BAB SHAMS POLICE STATION  
MOSUL, IRAQ

SUSTAINMENT ASSESSMENT

**SIGIR PA-06-091**  
**APRIL 25, 2007**

## **Bab Shams Police Station Renovation Mosul, Iraq**

**Site Photo 3.**

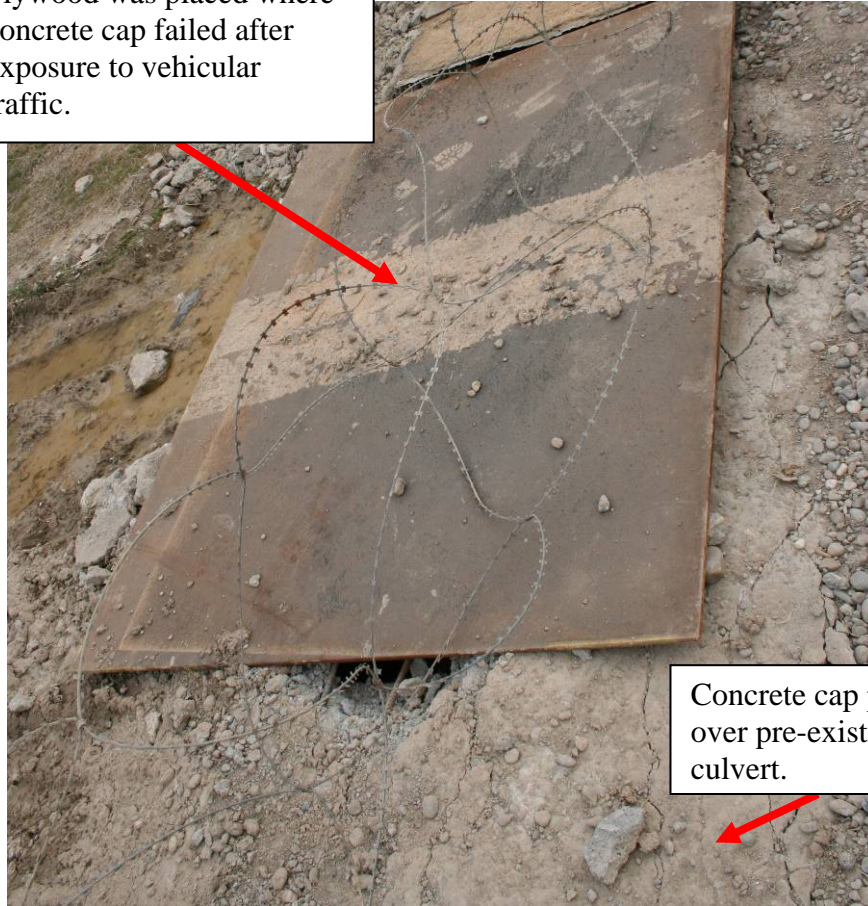
Rather than route sewer water around the perimeter of the station, the contractor merely capped the pre-existing open culvert with concrete. SIGIR inspectors observed that the construction of the concrete cap was poor for a number of reasons and had collapsed under the weight of vehicle traffic (Site Photo 3). As shown in Site Photo 4, the concrete was not uniformly mixed, was cast too thin and was cast without rebar or wire to improve the tensile strength.

In addition, forms should have been constructed in such a manner that the new concrete material would have been placed to touch the culvert's concrete side wall, which is concrete on concrete without wood between the new casting and the existing sidewall. The technique used by the contractor only increased the likelihood of concrete failure. As the wood rots, more stress is placed on the casting as it settles towards a concrete on concrete position.

Plywood was placed where concrete cap failed after exposure to vehicular traffic.

Concrete cap placed over pre-existing open culvert.

**Site Photo 4.**

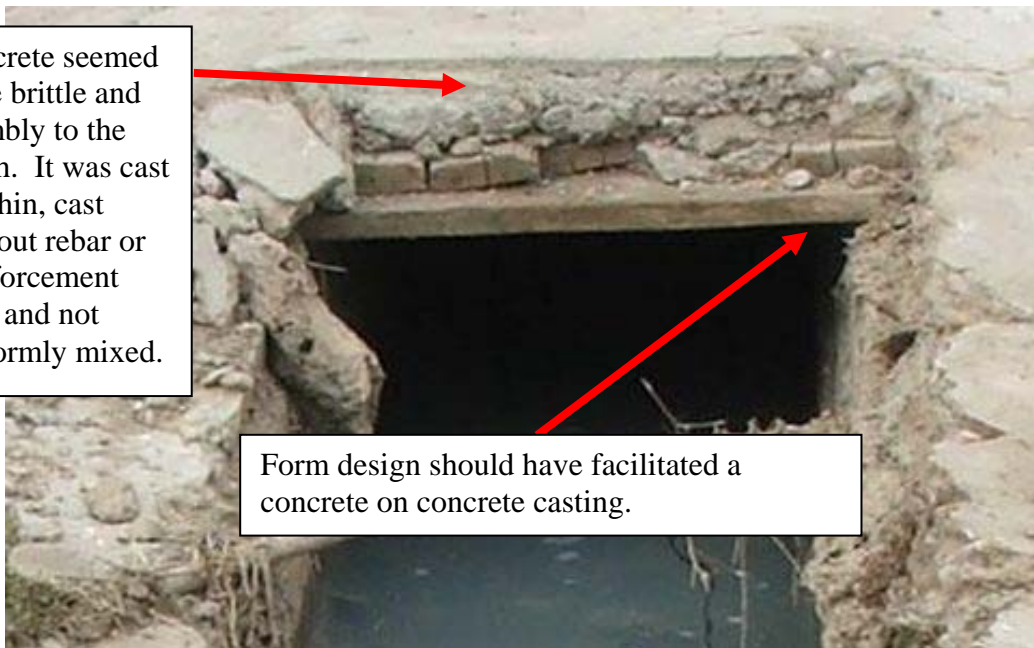
Concrete seemed to be brittle and crumbly to the touch. It was cast too thin, cast without rebar or reinforcement wire and not uniformly mixed.

Form design should have facilitated a concrete on concrete casting.

**Site Photo 7.**

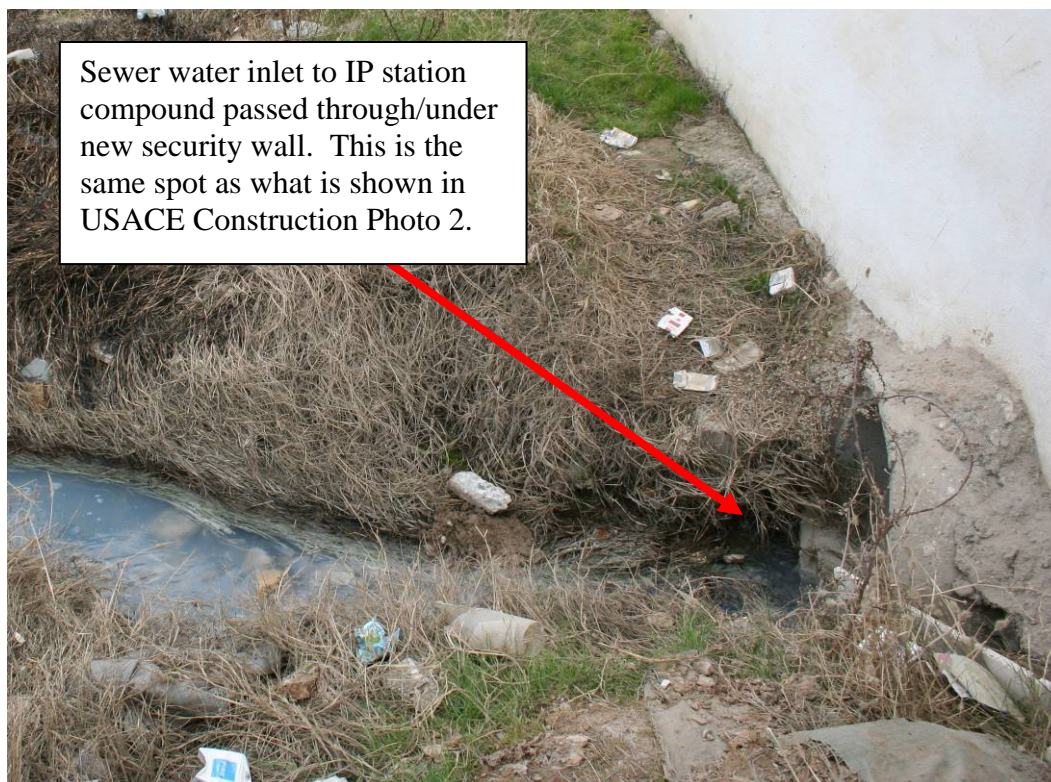
At the time of the site inspection, the conditions were dry and not impacted by recent rains. Nevertheless, Site Photo 7 shows that the open culvert on the high side or half of the compound was running free and able to handle the waste water volume entering the compound that day. However, Site Photo 8 taken at the exit and the open culvert's lowest spot within the confines of the compound shows the open culvert nearly full. It would not take much rain water runoff to create a flooded condition within parts of the IP compound area.

Sewer water inlet to IP station compound passed through/under new security wall. This is the same spot as what is shown in USACE Construction Photo 2.

**Site Photo 14.**

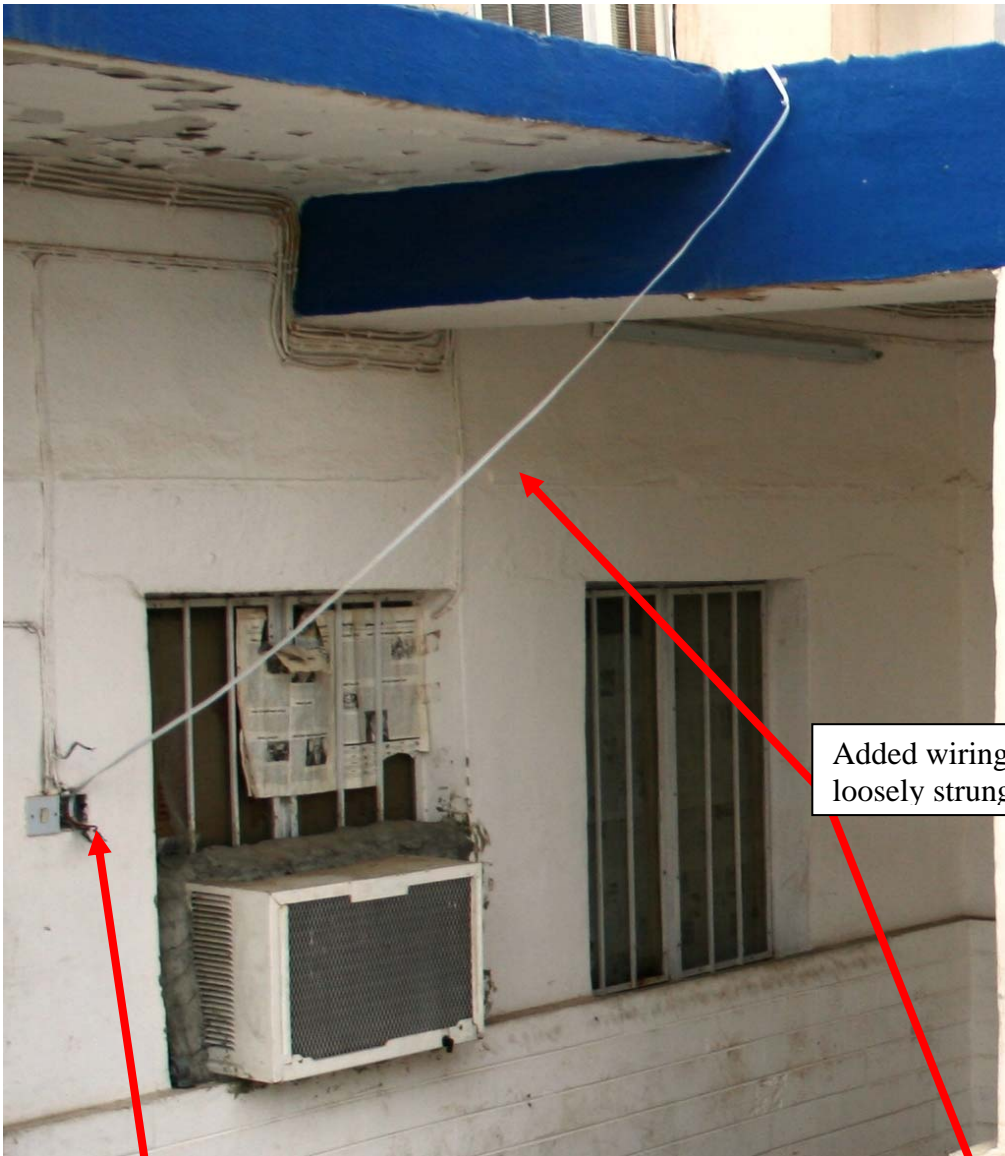
In Site Photos 14 and 15 a typical form of tampering observed by SIGIR inspectors is shown. Site Photo 14 shows how added wiring was loosely strung. Site Photo 15 is a close up and it shows the technique used to “tap into” an existing circuit. Specifically, the existing circuit and load requirement was maintained by twisting the wiring together in order to close the existing circuit. However, the “jury-rigged” wiring that fed a draw point only added to the circuit’s potential load or draw.

**Site Photo 15.**

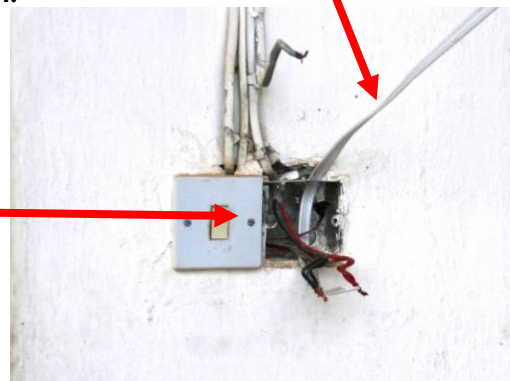
Switch or plug-in was removed and added wiring "tapped into" the circuitry.

**Site Photo 16.**

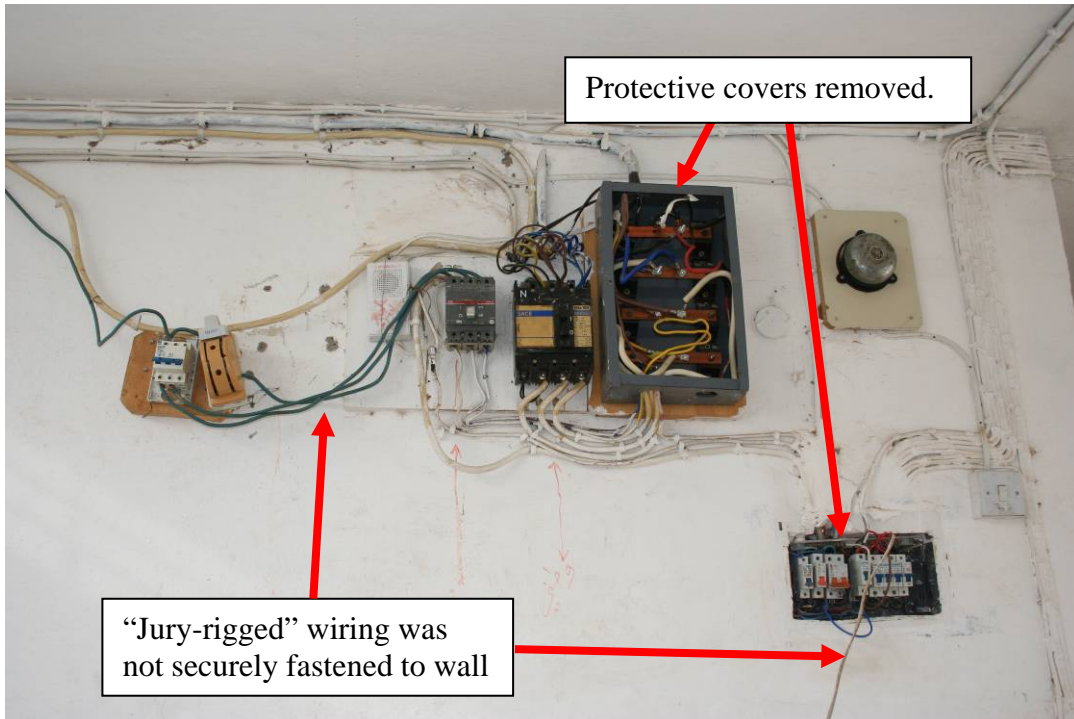
- USACE Construction Photo 5 shows where the contractor added electric system upgrades and properly covered and secured wiring. Conversely, Site Photo 16 taken at the same spot shows where covers were removed and energized system components were exposed. In addition, the photograph shows that “jury-rigged” wiring was added and not secured to walls.
